South Texas Project
Units 3 and 4
Docket Nos. 52-012 and 52-013
Supplemental Response to Request for Additional Information

RAI 03.07.01-27, Supplement 3**QUESTION:****Follow-up Question to RAI 03.07.01-19 (STP-NRC-100093)**

RAI 03.08.04-30 Supplement 2**QUESTION:****Follow-up to Question 03.08.04-23**

**Figure 3H.6-212: Lateral Seismic Soil Pressure (psf) on RSW Piping Tunnel East Wall
(Main Cross Section of RSW Piping Tunnel)**

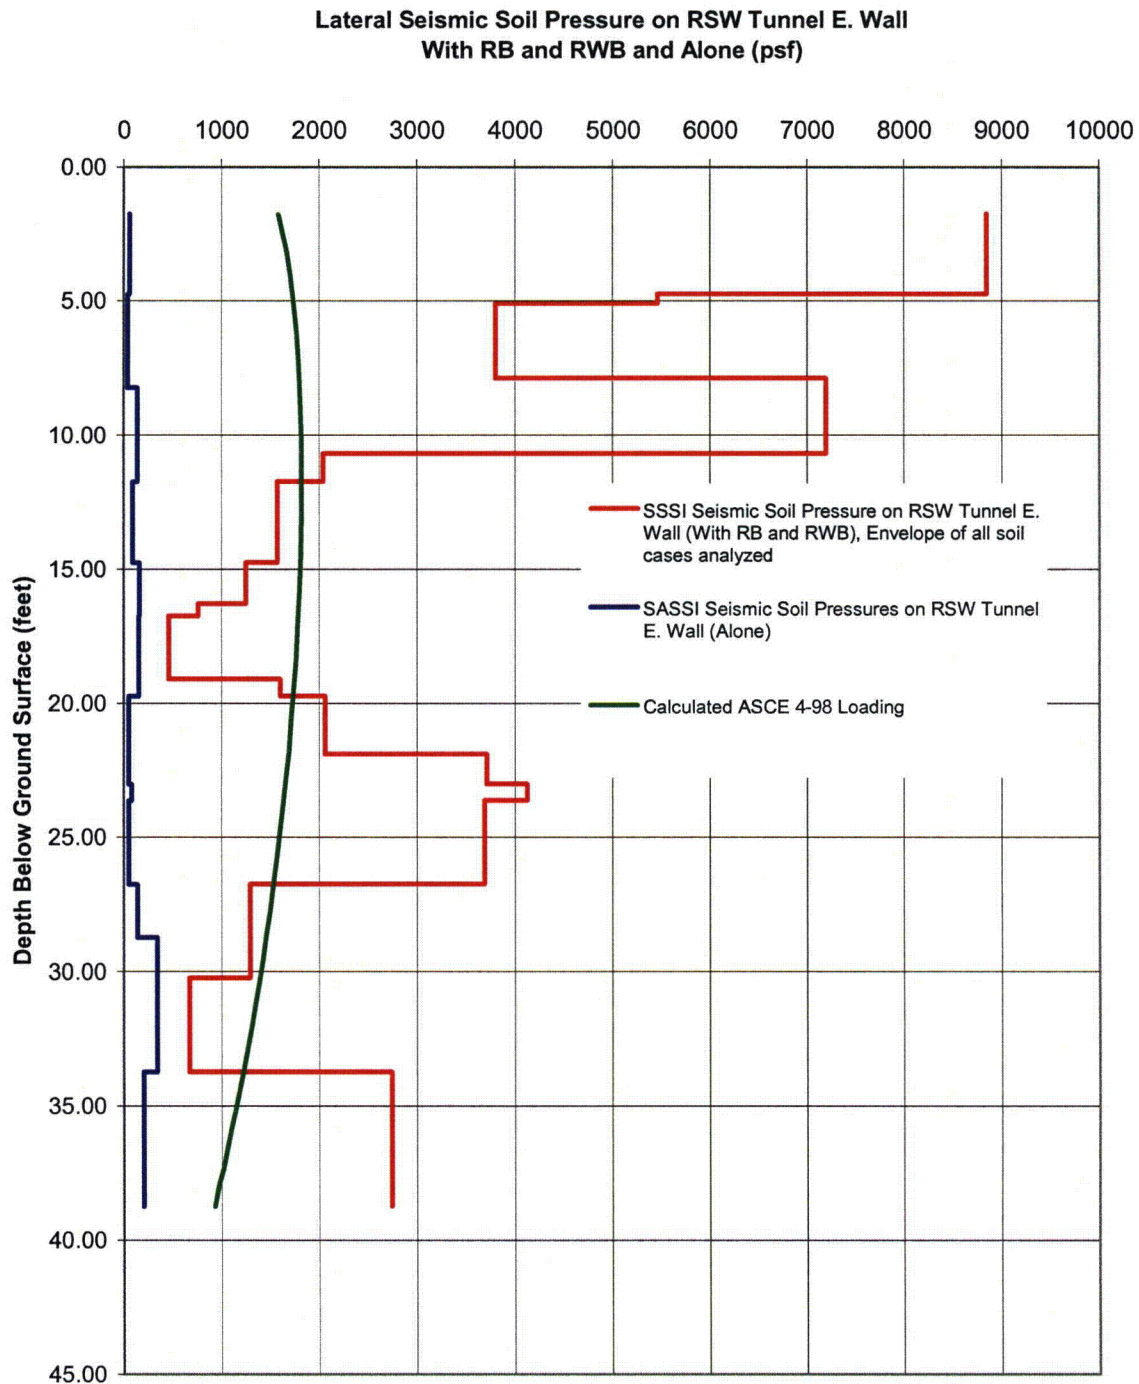
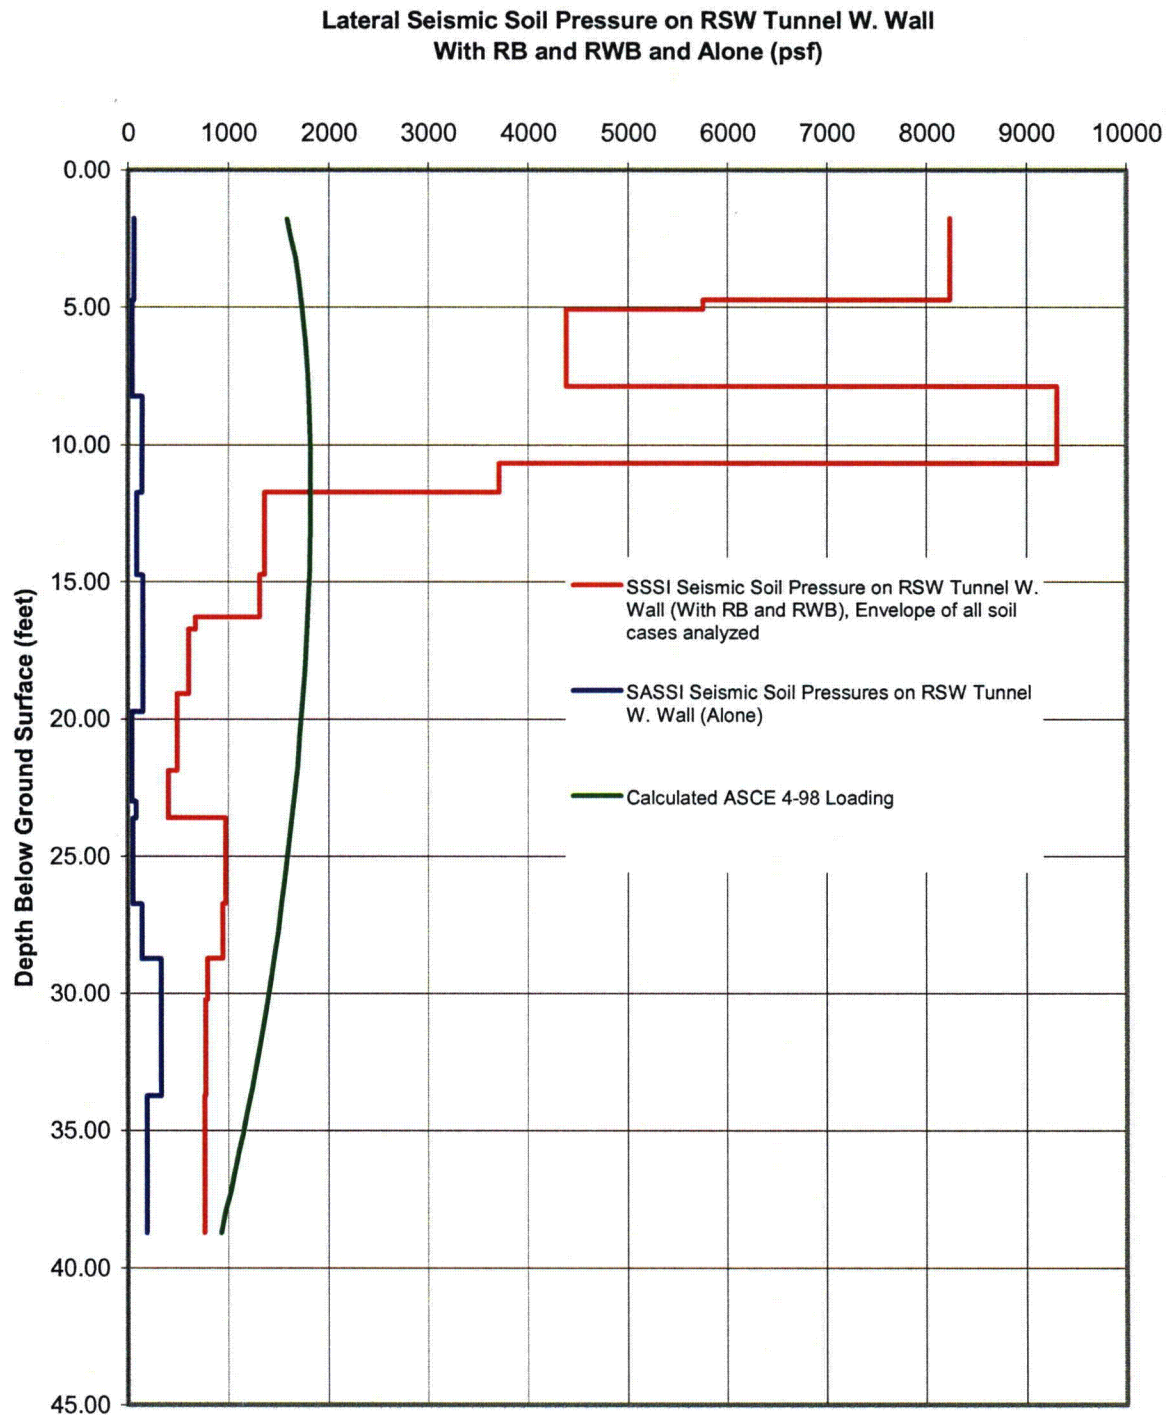
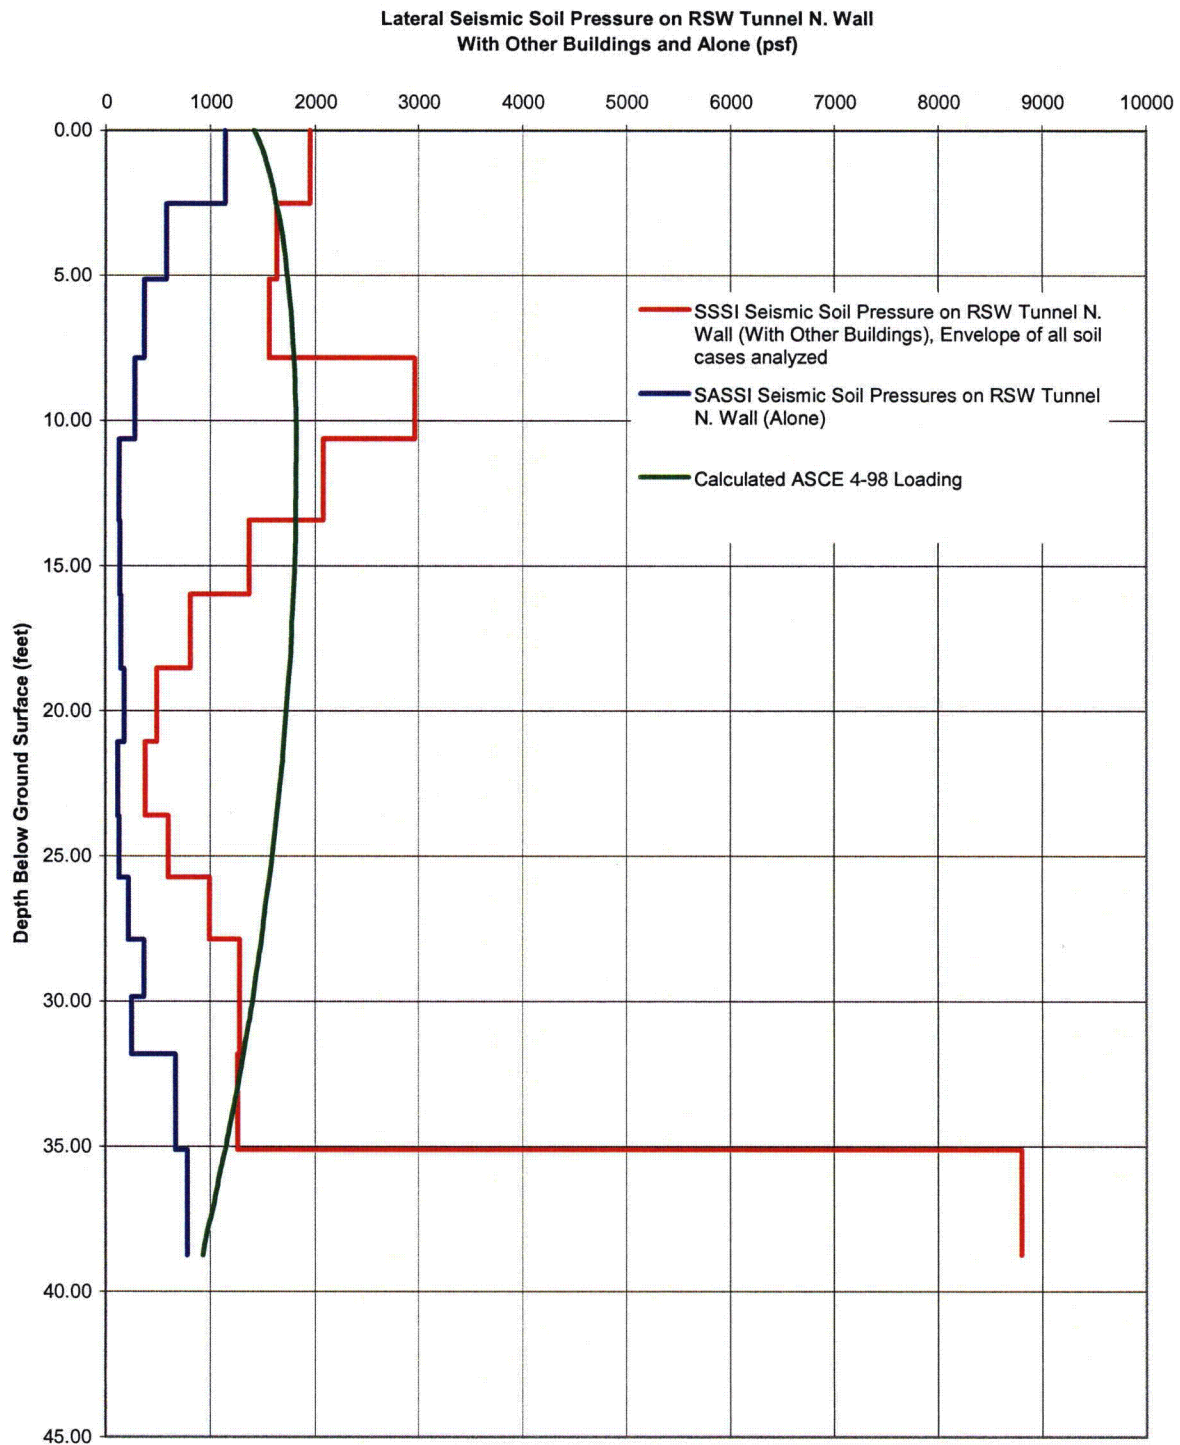
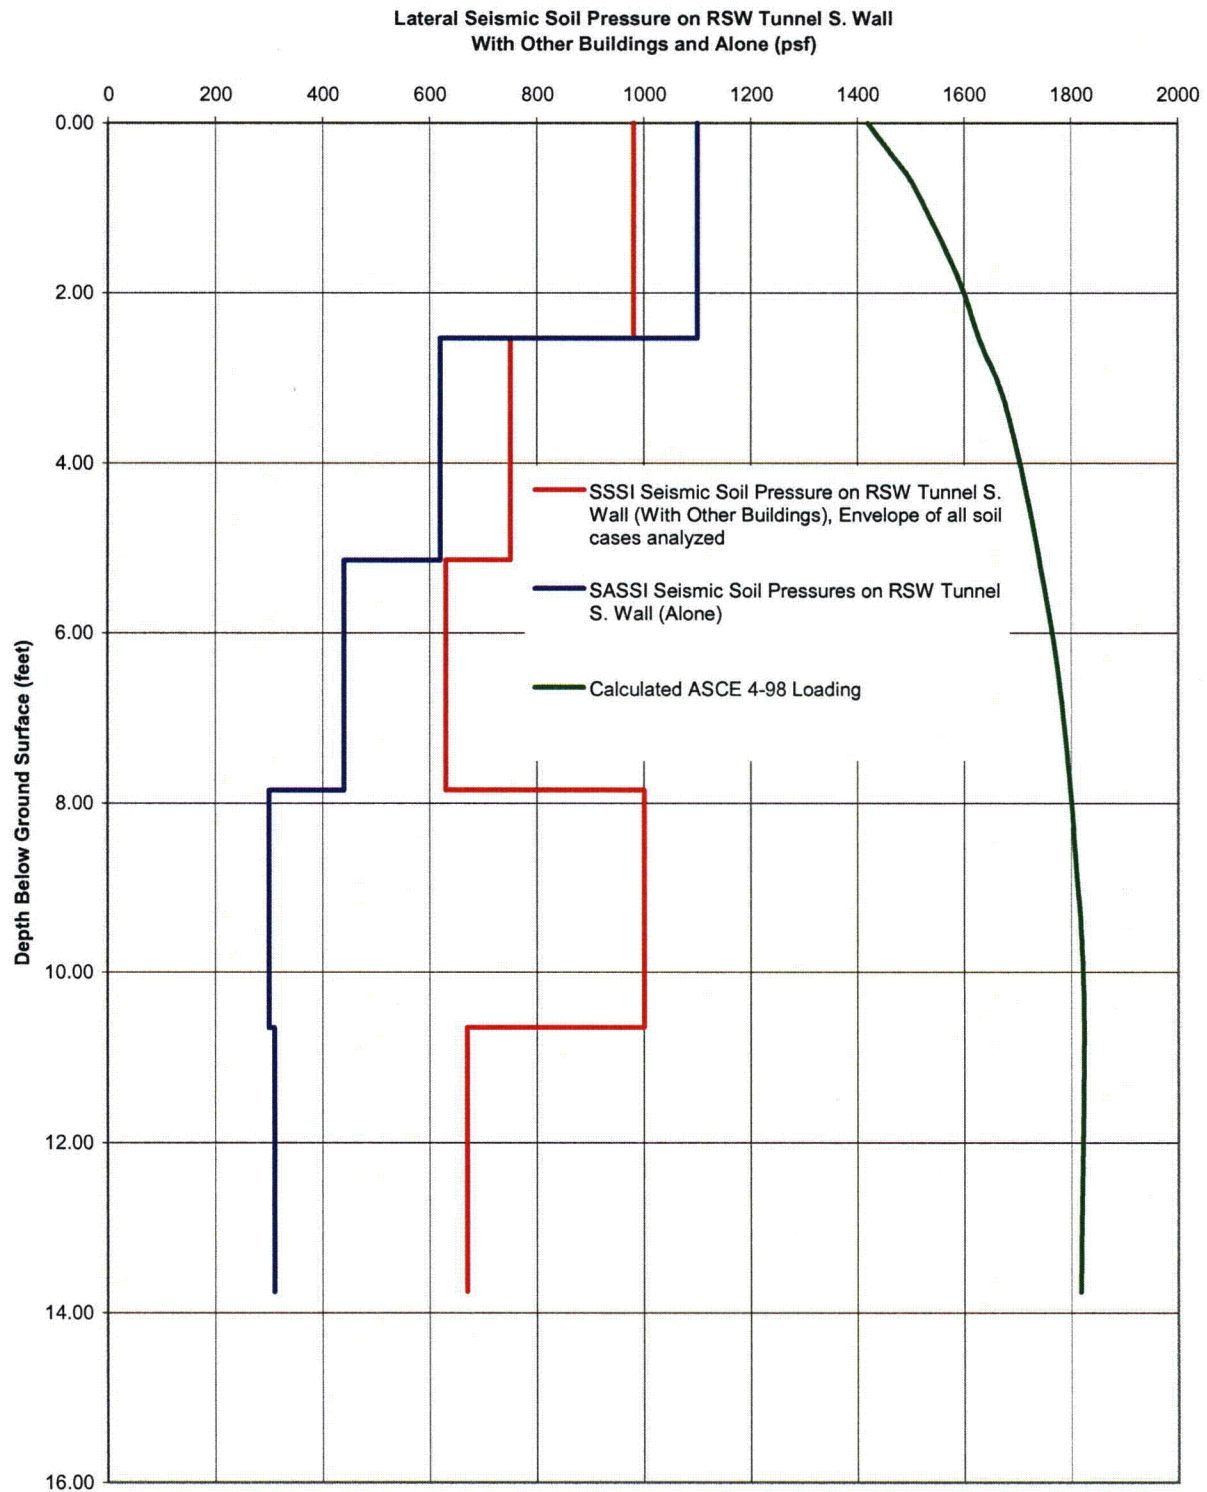
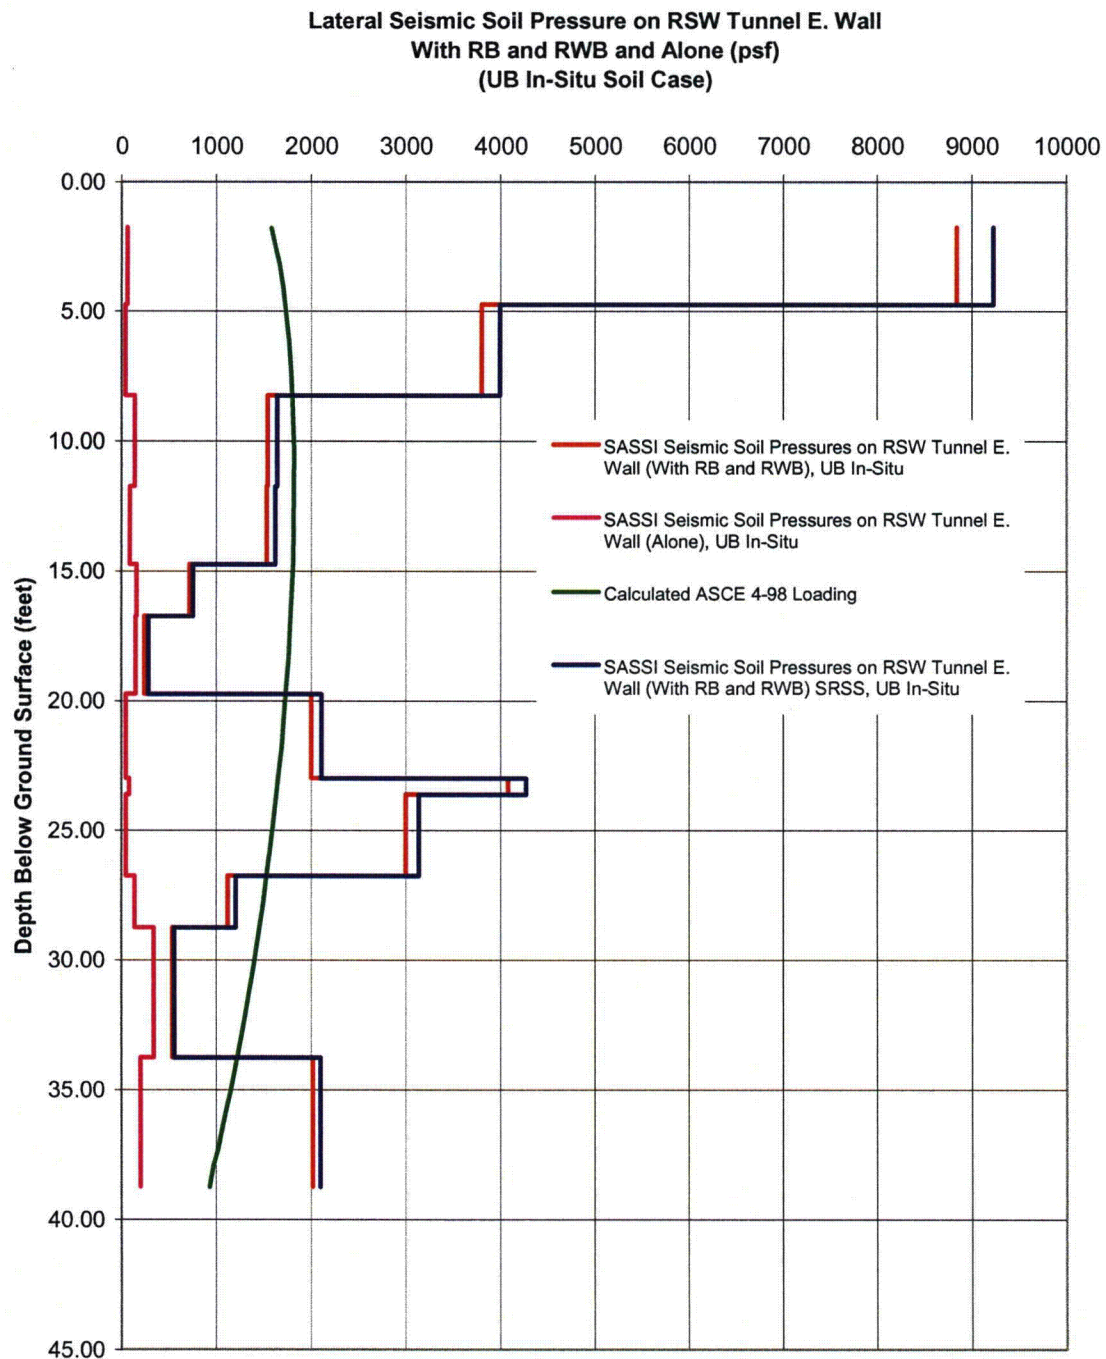
NINA was requested to discuss the soil cases for which the SSSI analyses for the RSW Piping Tunnel, DGFOVS, and DGFOT were performed. These cases should, as a minimum, include the upper bound in-situ and backfill soil cases. NINA was also requested to clarify the SSSI soil pressure figures in COLA to indicate that those represent envelop of all soil cases analyzed (Audit Action Items 3.7-6, 8, 10, and 36). Finally, NINA was requested to provide information regarding the following Clarification Issue 2, as provided by the NRC.

The following revised COLA figures showing SSSI soil pressures, based on envelope of all soil cases analyzed, are provided in the Enclosure.

Control Building:	Figure 3A-302
Reactor Building:	Figures 3A-301, and 3H.1-1 through 3H.1-6
Radwaste Building:	Figures 3H.3-50 and 3H.3-51
RSW Piping Tunnel:	Figures 3H.6-212 through 3H.6-217
UHS/RSW Pump House:	Figures 3H.6-218 through 3H.6-220
DGFOSV:	Figures 3H.6-226 through 3H.6-231
DGFOT:	Figures 3H.7-5 through 3H.7-8
